ADDENDUM #2

FOR
VON RENNER ELEMENTARY SCHOOL: CLASSROOM BUILDING
FOR
NEWMAN-CROWS LANDING UNIFIED SCHOOL DISTRICT
Bid Time and Date: October 21, 2026 at 3:00 p.m.

VON RENNER ELEMENTARY SCHOOL:
CLASSROOM BUILDING

DEMOLITION PLAN

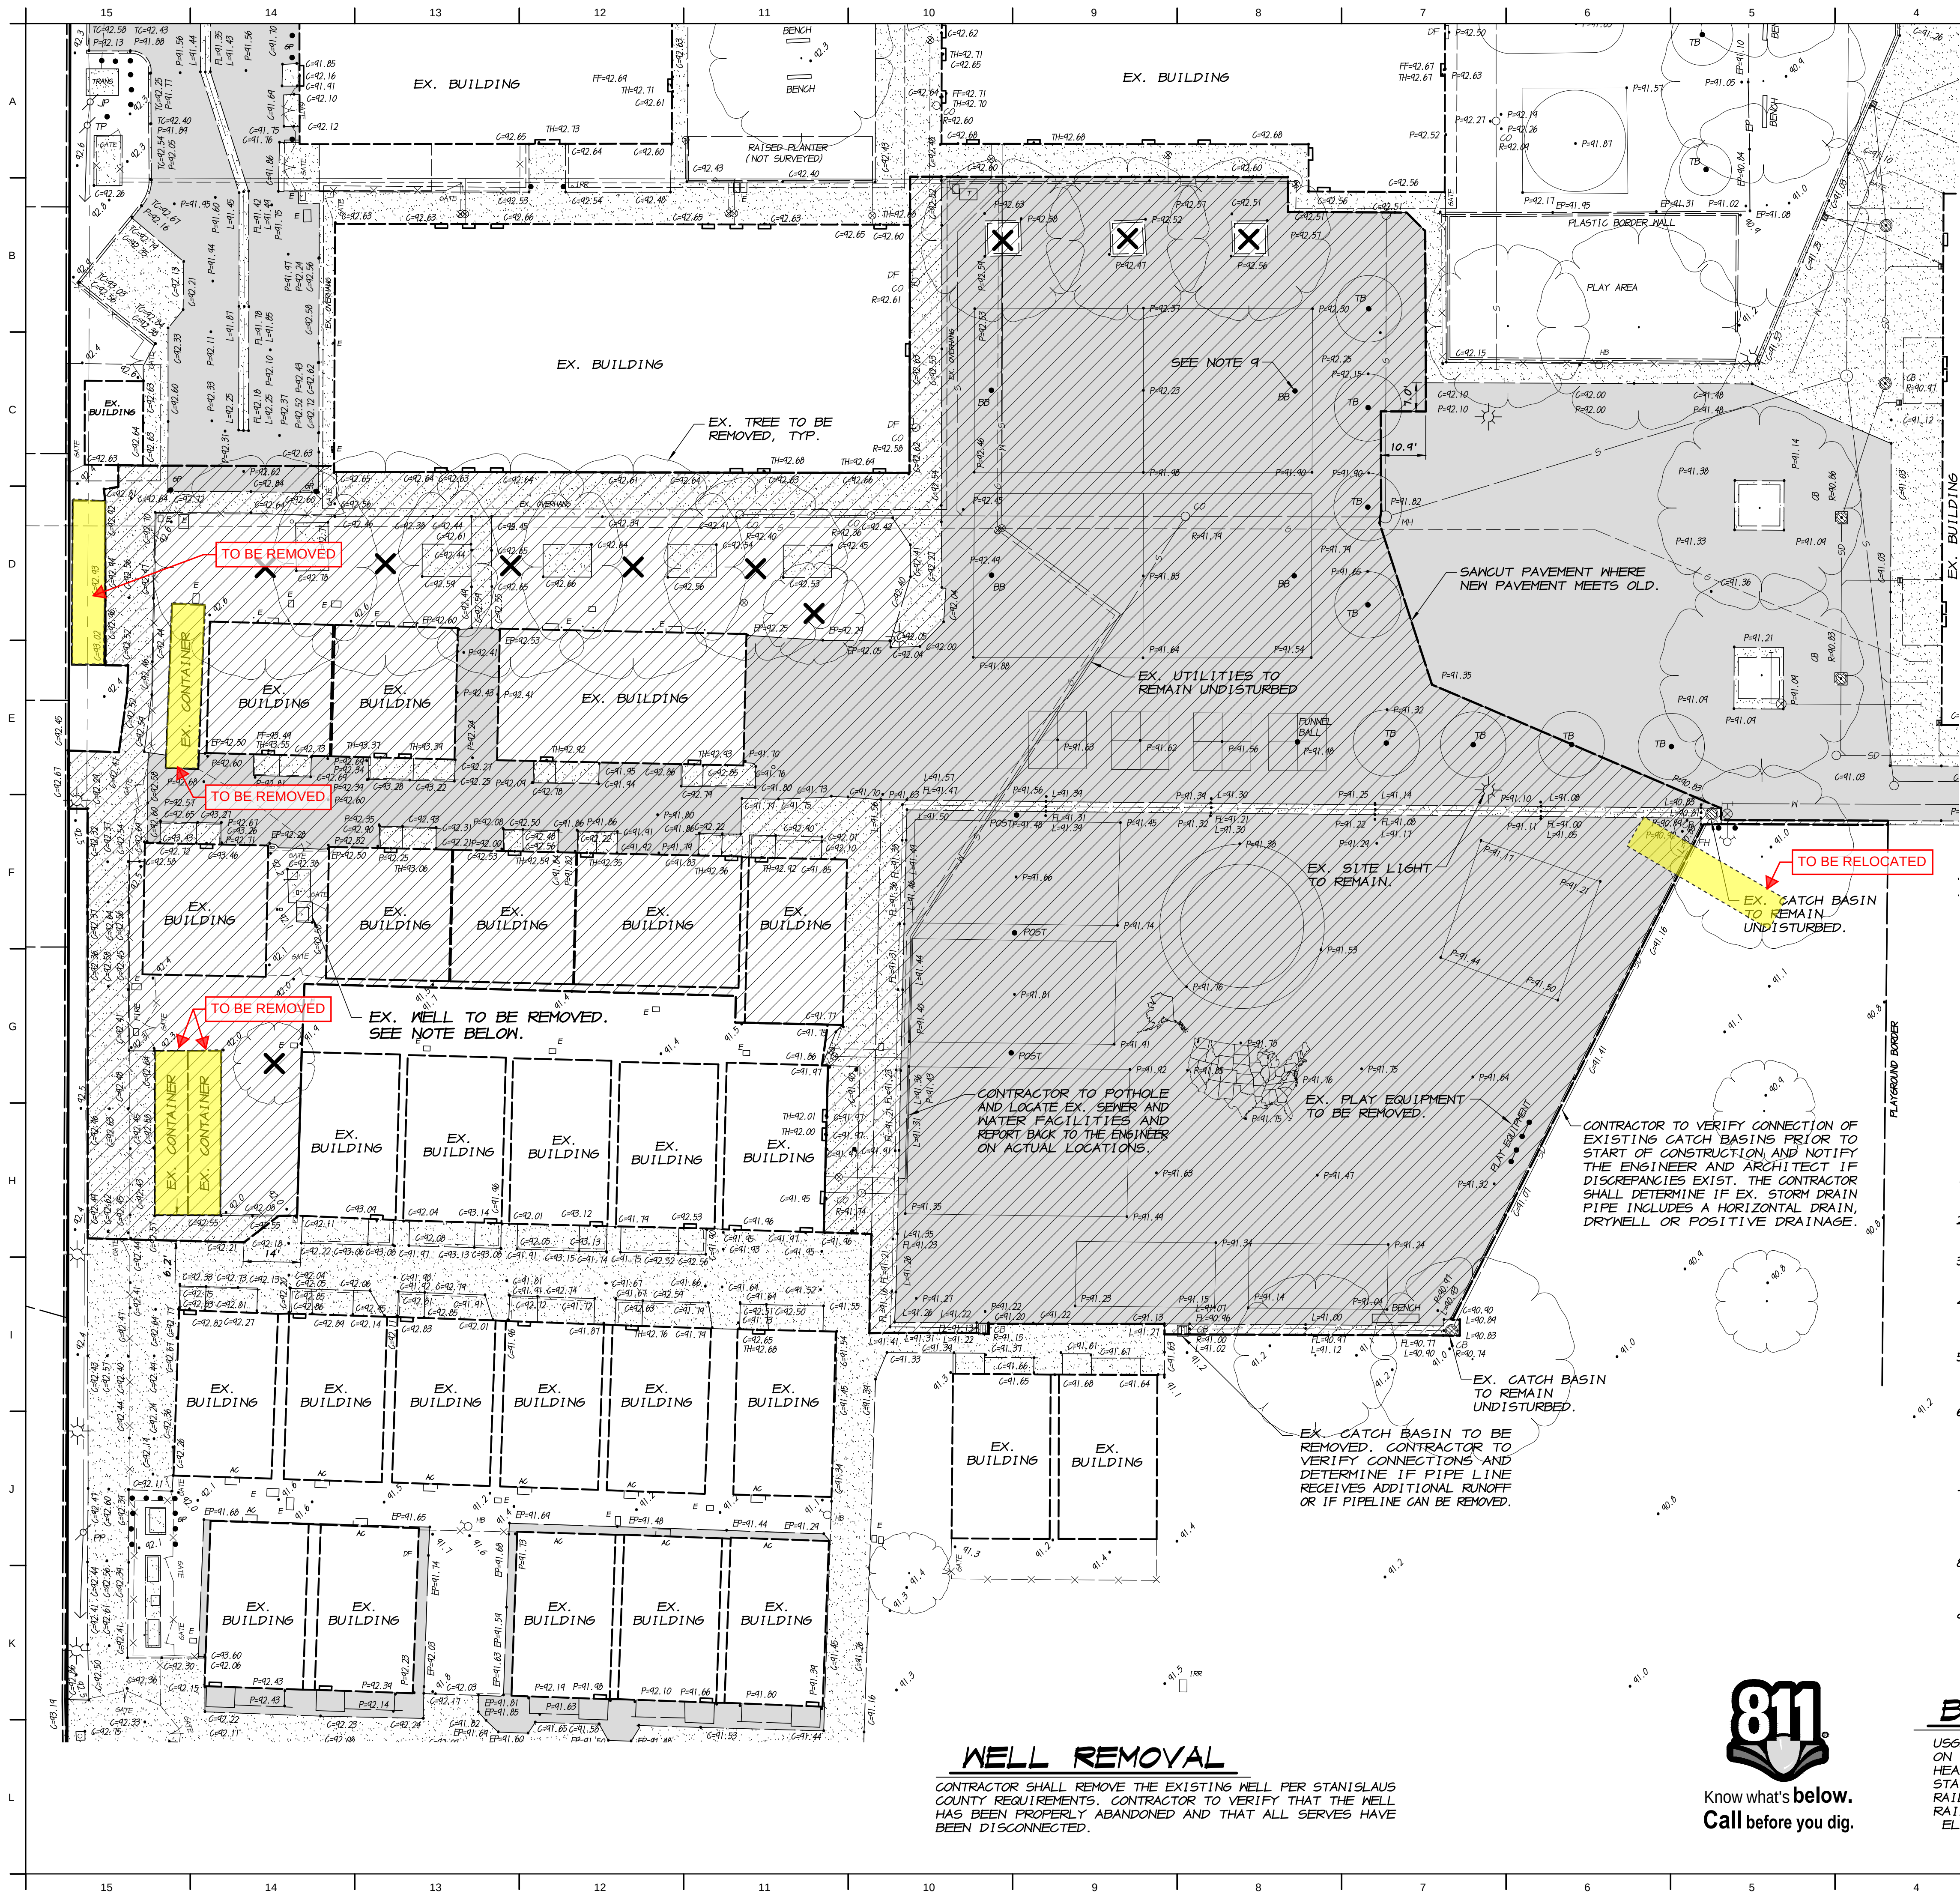
- Item 001.: Reference Sheet C3.0 – Existing Metal Cargo Containers:
There (4) existing cargo containers along the western property line that are to be demolished, and one in the play court that is to be relocated out of the area of work – see attached exhibit ADD-2.1.

~~CS-0~~
ADD 2.1

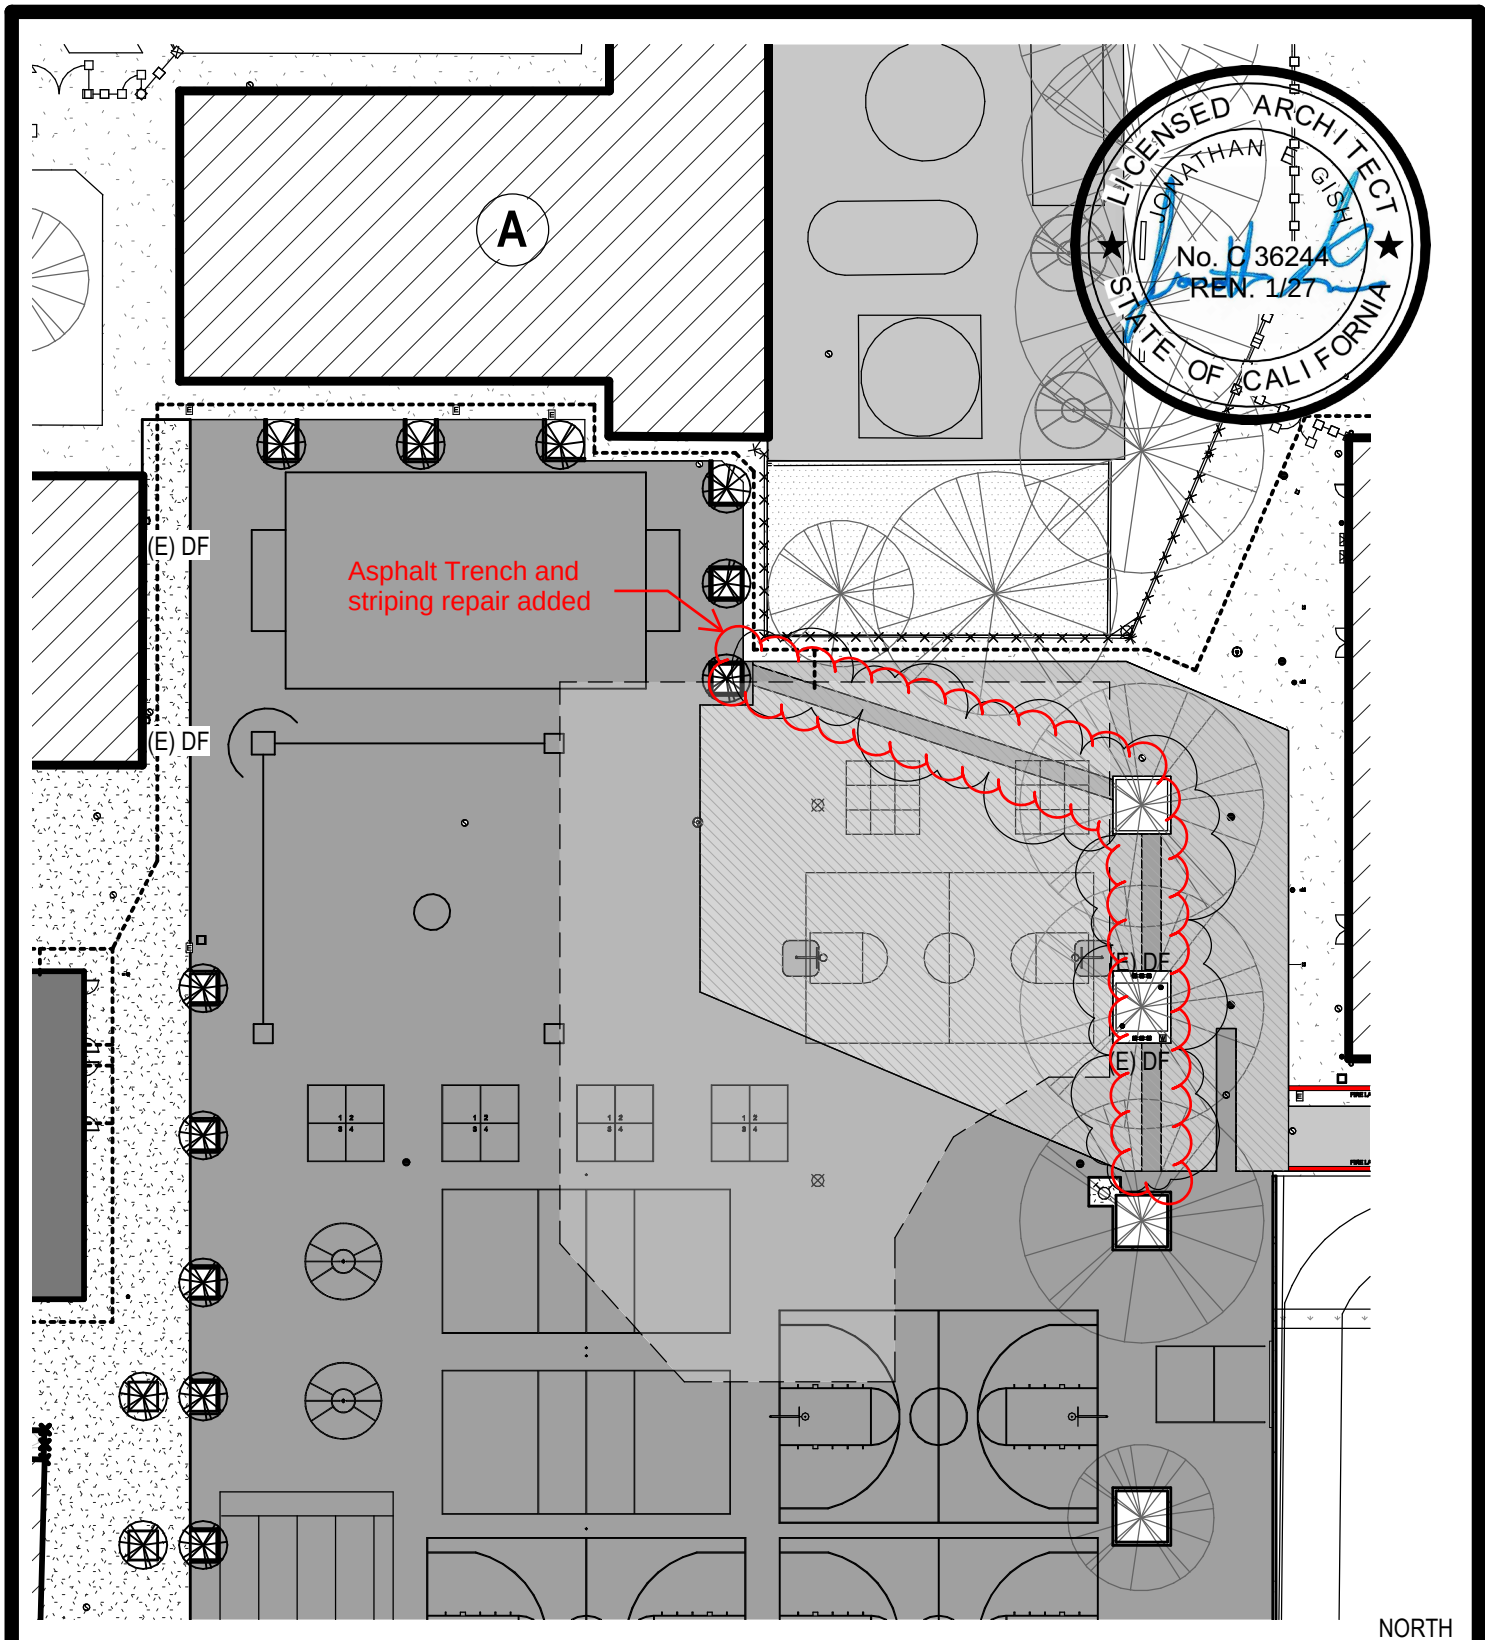
- Item 005.: Reference Sheets AS-1.2 and L1.2 – New Irrigation Lines at Existing Asphalt:
Additional asphalt patching is required to accommodate the new irrigation lines – see attached exhibit ADD-2.2.

ADD_A2.3

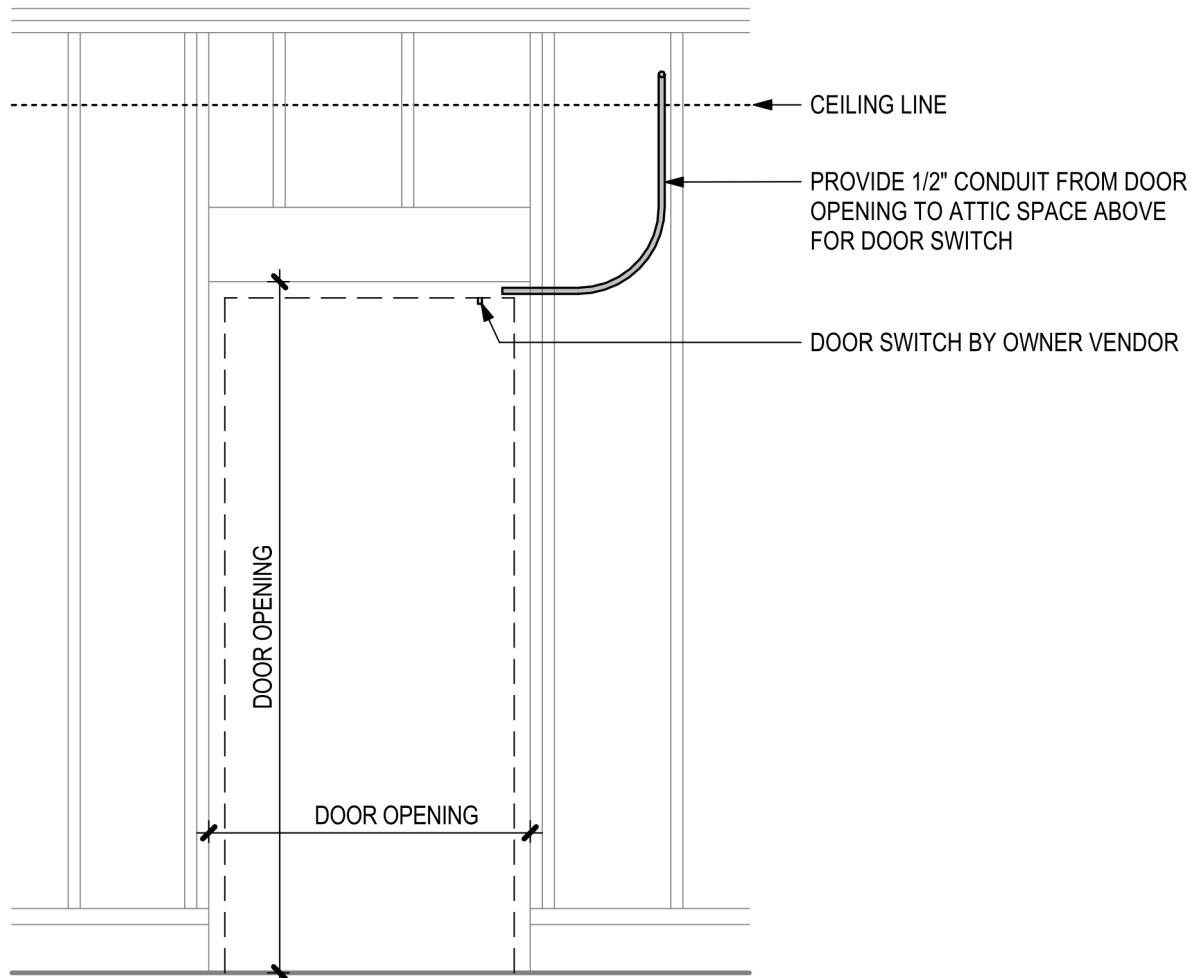
- Item 039: Plan sheet E0-1.1 references "Sonitrol coordination for building H" which seems to require conduits and door switches which don't seem to be shown on the electrical site plans or the signal floor plans. Also, there is no building H on this project site. Please confirm if this scope of work applies and if so provide conduit paths, sizes, locations and device information.
(The note should reference "Building F". See attached exhibit ADD-2.3.)
